REVIEW TYPE: Preliminary Plan of Subdivision

PROJECT NAME: Norwood Road
CASE #: 120070150
REVIEW BASIS: Chapter 50, Montgomery County Subdivision Regulations

RECOMMENDATION: Denial, pursuant to Section 50-29(a)(1)

Attachment A – Proposed Development Plan

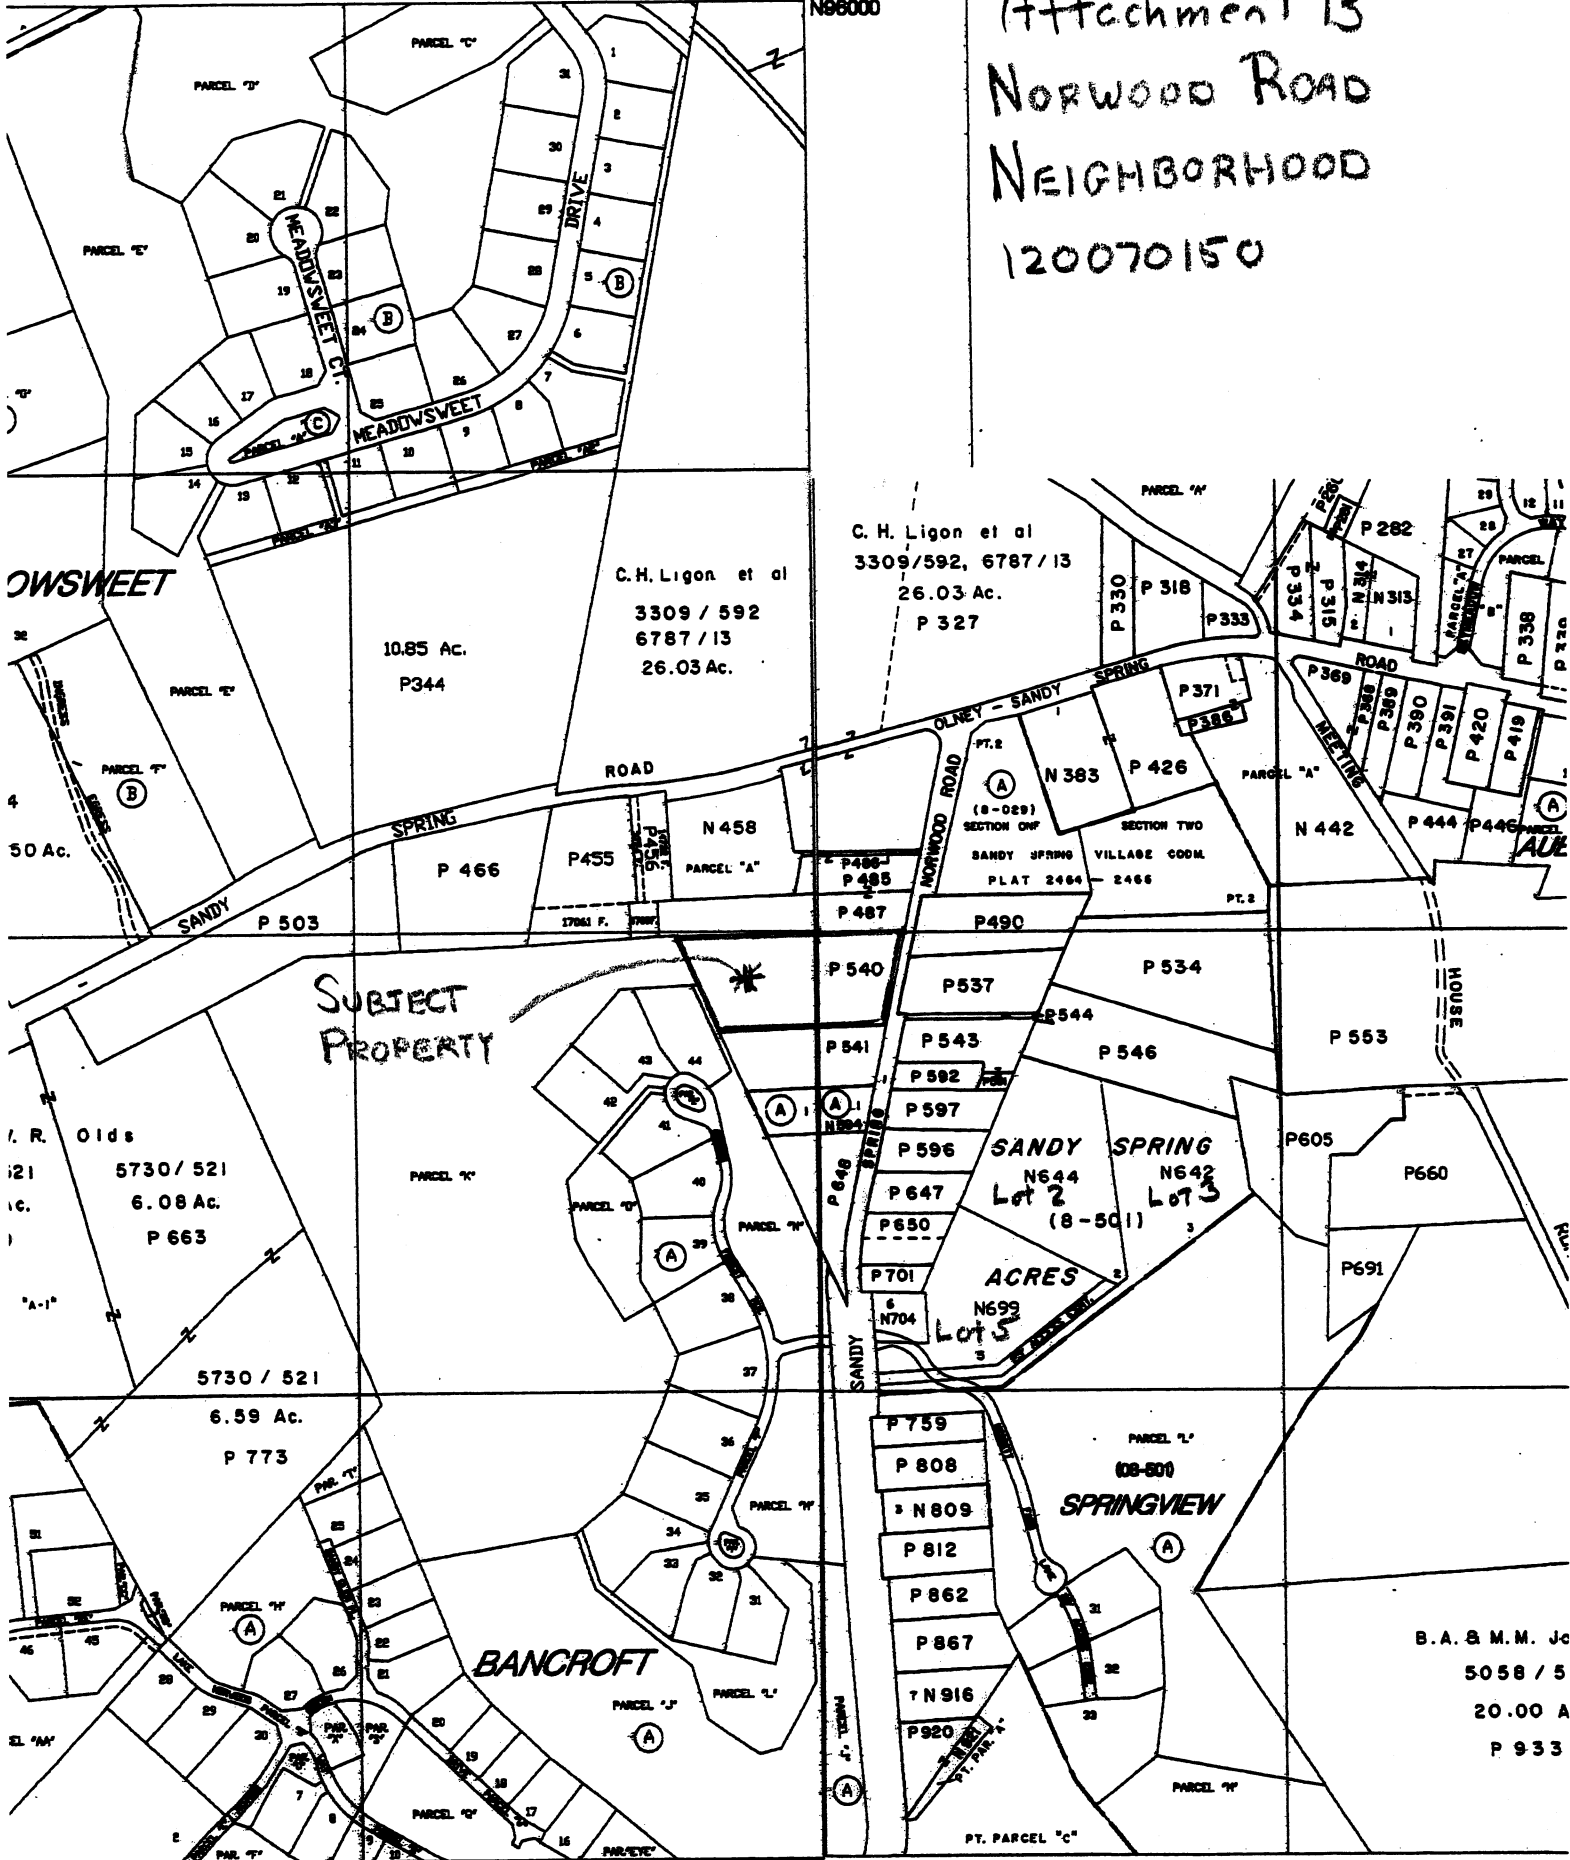
For this application, staff objects to the orientation of proposed Lot 2 as it relates to Lot 1. In staff’s opinion, this lot orientation is not appropriate because it establishes an alignment of one lot directly to the rear of another lot. The lot orientation will bring about an undesirable front to rear orientation of homes. This type of orientation is not duplicated elsewhere in the neighborhood and staff believes, as further discussed below, it is an undesirable lot relationship and does not conform to the language expressed in 50-29(a)(1). The approval of such an alignment in this neighborhood would also likely establish a precedent for future requests of a similar layout.

The orientation issue in this instance is heightened by the relatively small size of the lots in question at 20,158 and 27,737 square feet, respectively. The location of the proposed home on Lot 2 has little room to shift and will necessarily be to the rear of the existing home on Lot 1. The homes are shown to be approximately 100 feet from one another but even if the home on Lot 2 were to be moved further away (to the west) from the existing home on Lot 1, the “stacking” of homes from the street view would remain the same, and this is a relationship that staff strives to avoid. To mitigate this, the applicant has proffered a landscape buffer that attempts to provide some measure of visual screening and privacy for the two homes. Staff does not believe, however, that a landscape buffer can fully ameliorate the orientation problem.

Staff would perhaps be supportive of pipestem lots in this location if the proposed subdivision could front two lots on Norwood Road with one to the rear. But, because of the Property’s current width, there are not enough linear feet to create two 100 foot wide lots fronting Norwood Road while allowing a 25 foot pipestem to the rear lot. This would only be possible with a waiver of frontage; however, staff cannot find any exceptional circumstances upon which a waiver may be granted for this application.
